**TOWN OF MOUNTAIN VILLAGE  
REGULAR DESIGN REVIEW BOARD MEETING  
THURSDAY NOVEMBER 1, 2018 10:00 AM  
2nd FLOOR CONFERENCE ROOM, MOUNTAIN VILLAGE TOWN HALL  
455 MOUNTAIN VILLAGE BLVD, MOUNTAIN VILLAGE, COLORADO  
AGENDA**

**TO:** Design Review Board  
**FROM:** Sam Starr, Planner  
**FOR:** Meeting of November 1, 2018  
**DATE:** October 26, 2018  
**RE:** Consideration of a Final Review application for a new single-family dwelling on Lot 649R Unit 8, 8 Boulders Way

**RE:** Consideration of a Minor Revisions application to an approved landscape plan at Lot 1151, 132 High Country Drive

Drainage Plan

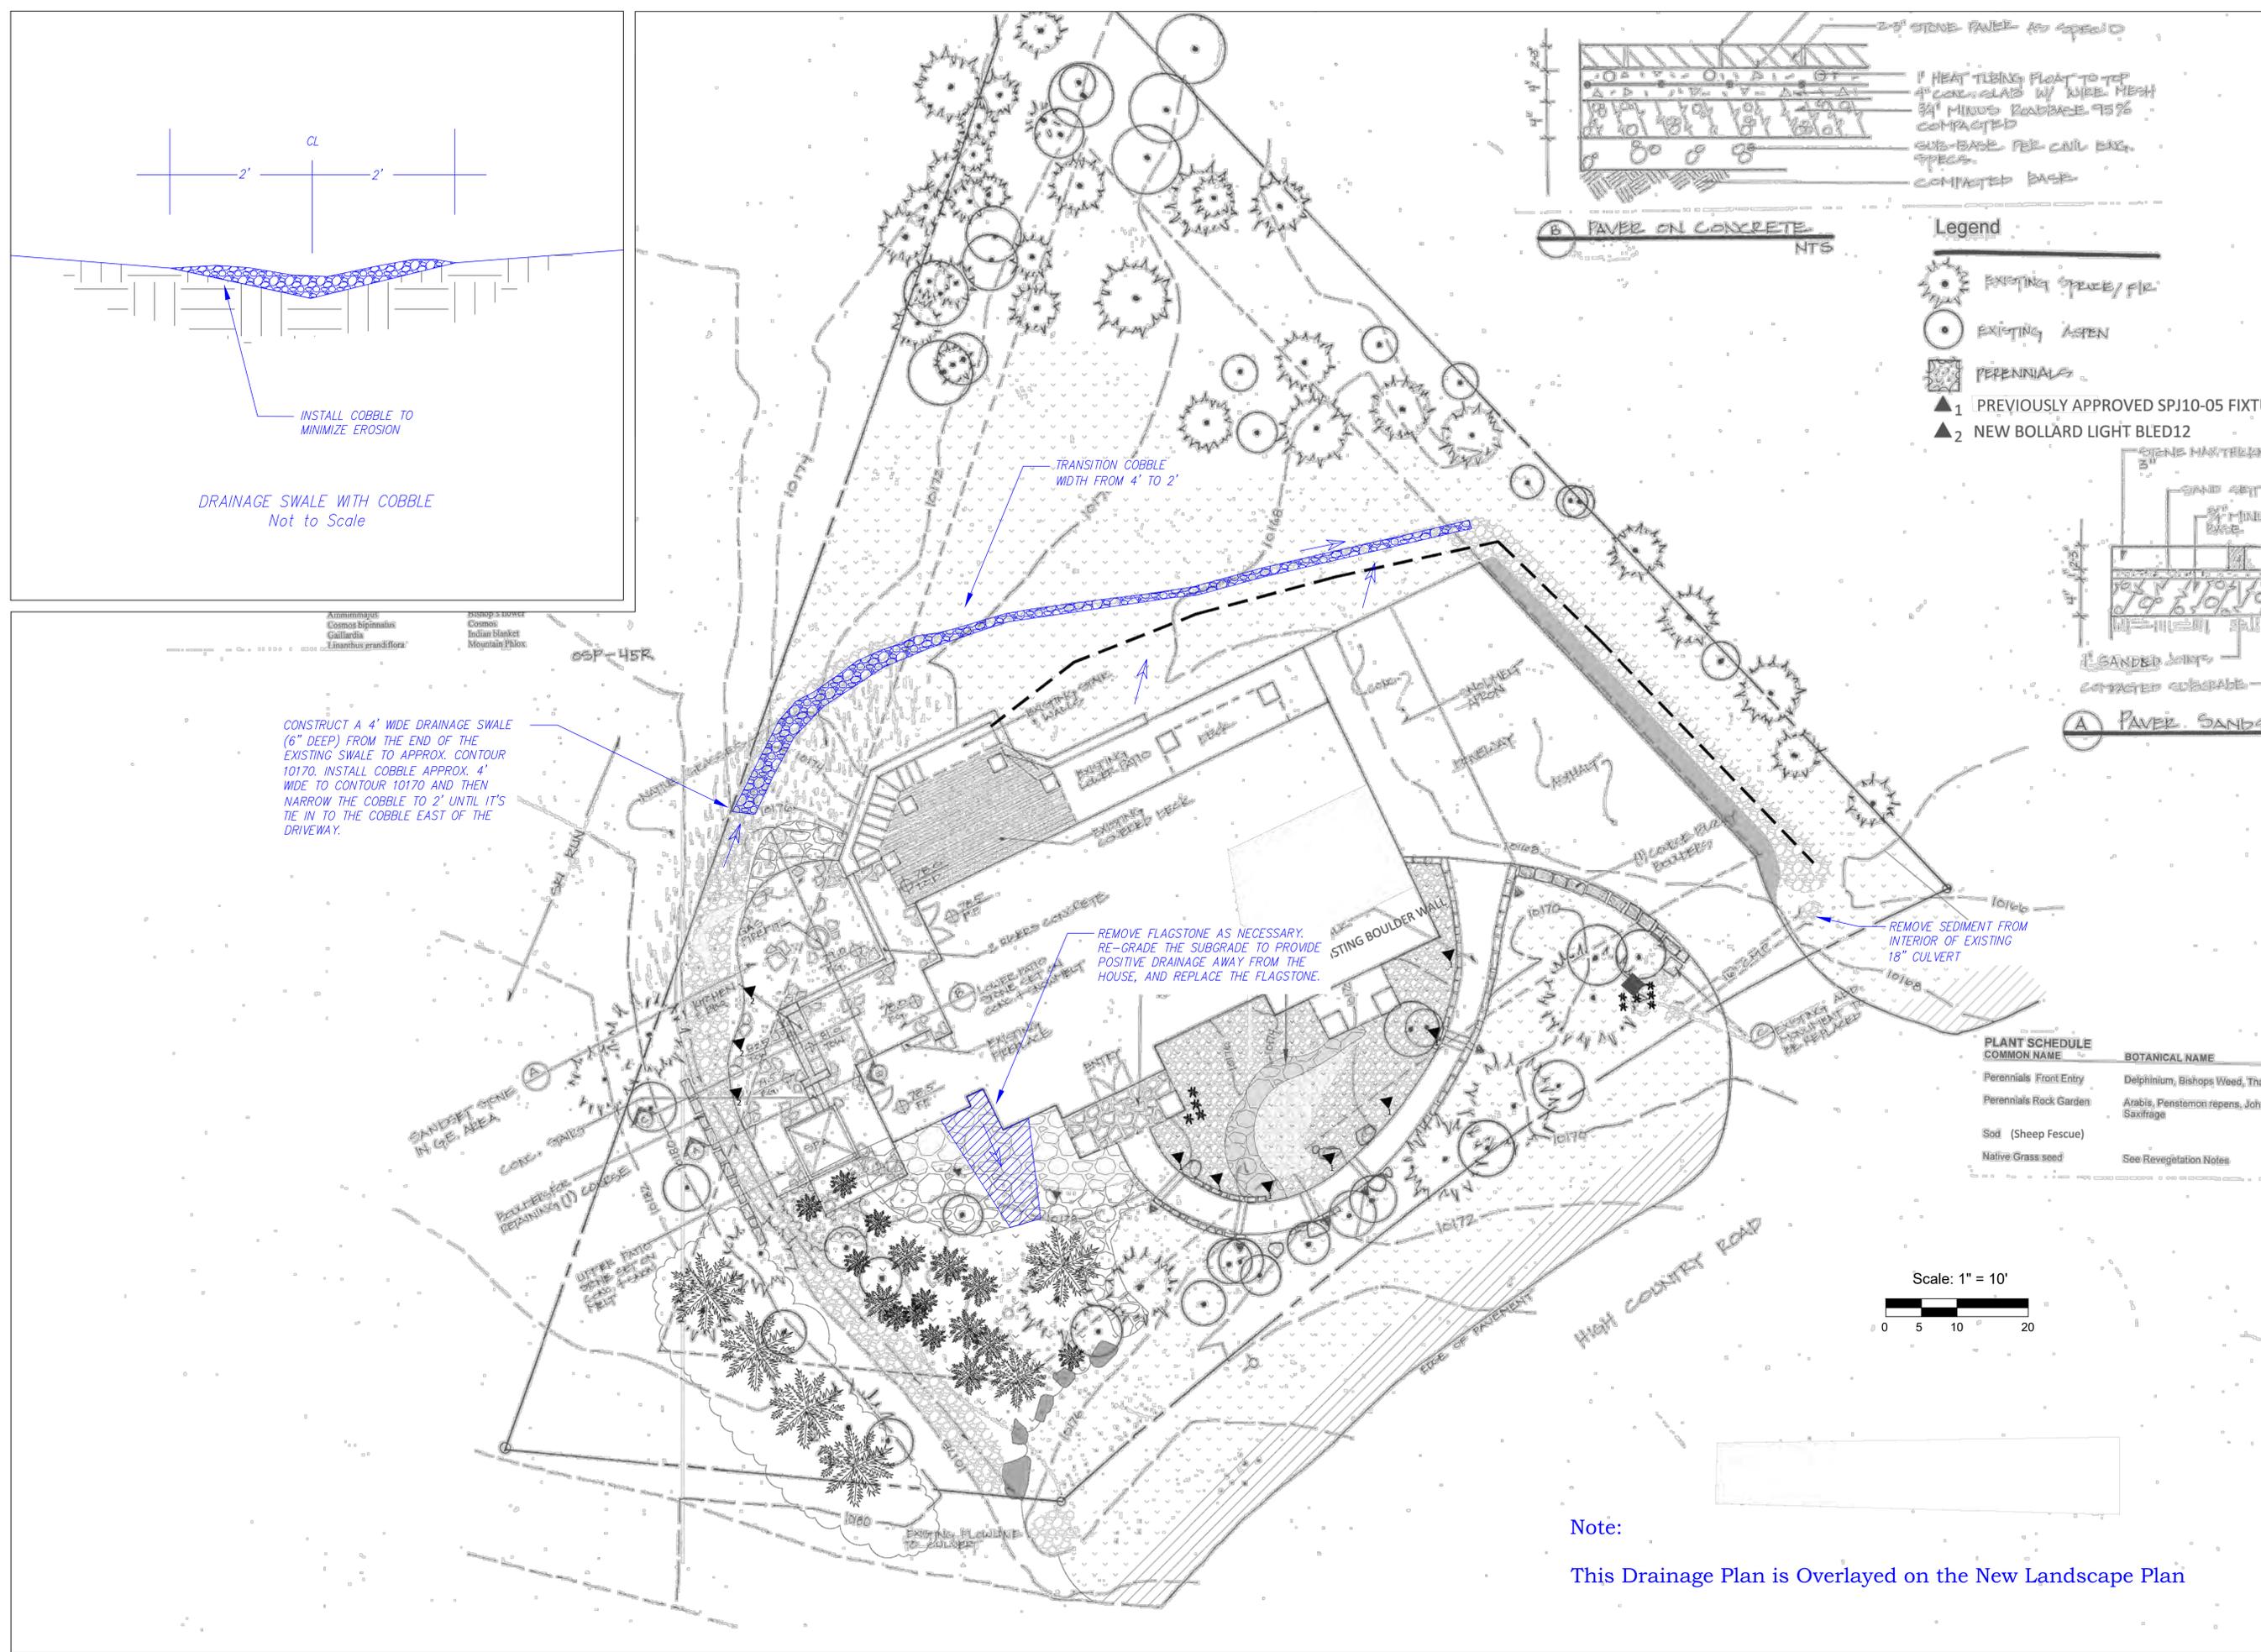
The applicant provided a drainage plan prepared by Uncompahgre Engineering (exhibit C) which is integrated into the revised landscape plan pursuant to the DRB condition of continuance. Generally, the drainage plan notes the following proposed changes:

- Reduce the width of the proposed cobble swale to the north from 4 feet to 2 feet.
- Extend the cobble swale to the north and west to tie in with existing cobble swale.
- Regrade a portion of the flagstone patio to provide positive drainage.
- Reduce the width of the cobble by approximately 40" in the east general easement.
- Remove cobble to the south (south of front walkway) and landscape.
